Product Change Notification

**PCN-038_2023_0-OMTS2314201+S2314202+S2314203
+S2316401+S2316402**

**Change of subcontractor making the plastic parts
ARH; ART; IT60-400; IT700-1K; ITN6&900; LF210-S
and LF310-S series**

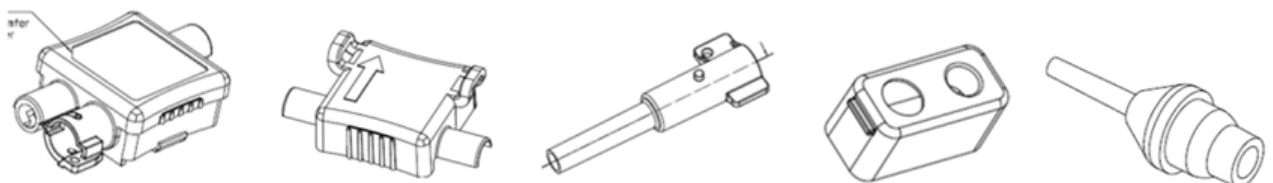
For IT700-1K; ITN6&900; IT60-400 models this is concerning the shield protection plastic flanges.
